Product Change Notification / NTDO-09RUGQ249

CCB 4645 Final Notice: Qualification of MPHL as additional final test site for selected ATSAMA5D3xA device families available in 324L LFBGA (15x15x1.4mm) package.

CCB 4645
Pre and Post Change Summary
PCN #: NTDO-09RUGQ249

Carrier Tape for T/R

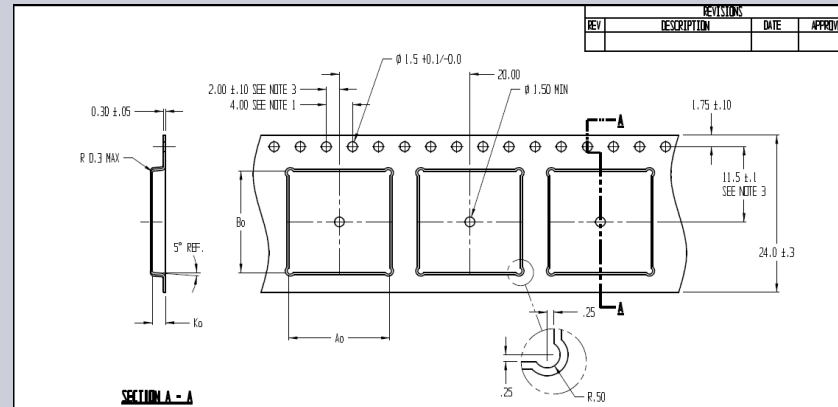
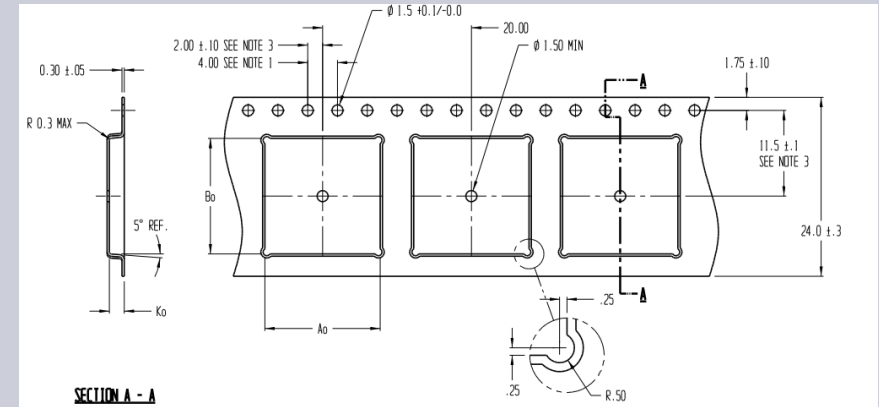
Width (mm)	Pitch (mm)	A0 (mm)	B0 (mm)	K0 (mm)	Thickness
24	20	15.5	15.5	2.0	0.3

Width (mm)	Pitch (mm)	A0 (mm)	B0 (mm)	K0 (mm)	Thickness
24	20	15.5	15.5	2.0	0.3

Cover Tape for T/R

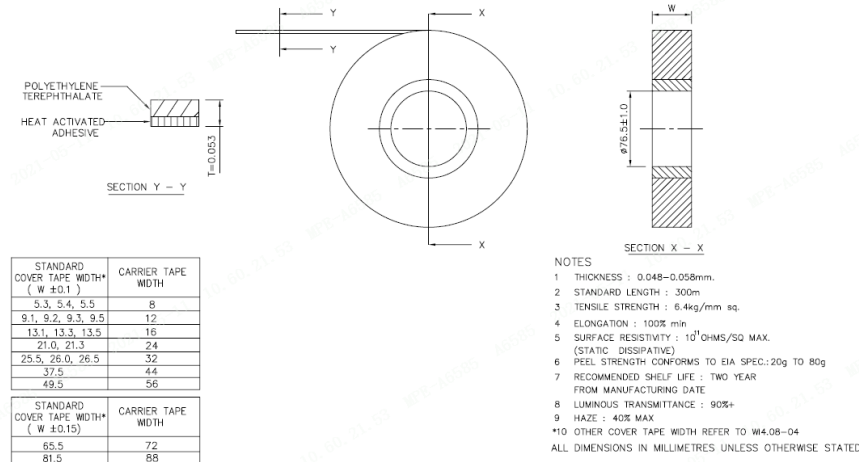
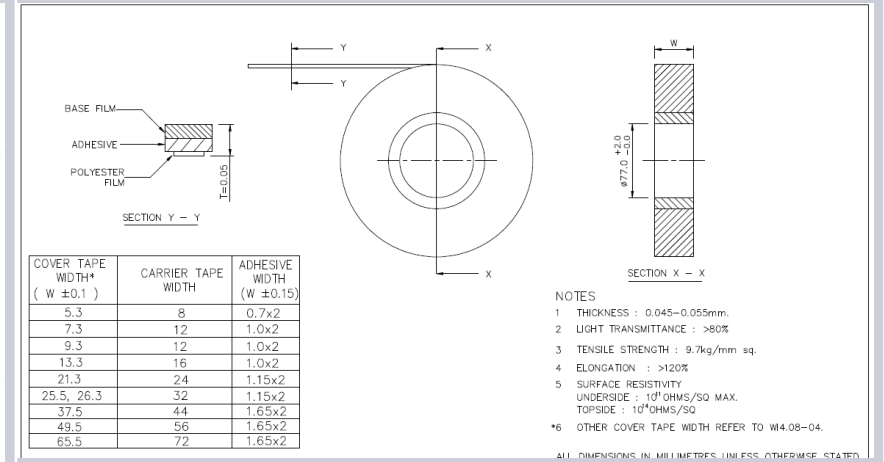
Width W (mm.)	Thickness T (mm.)	Sealing Methodology
21.3	0.048-0.058	Heat Active Type

Width W (mm.)	Thickness T (mm.)	Sealing Methodology
21.3	0.045-0.055	Pressure Seal Activated
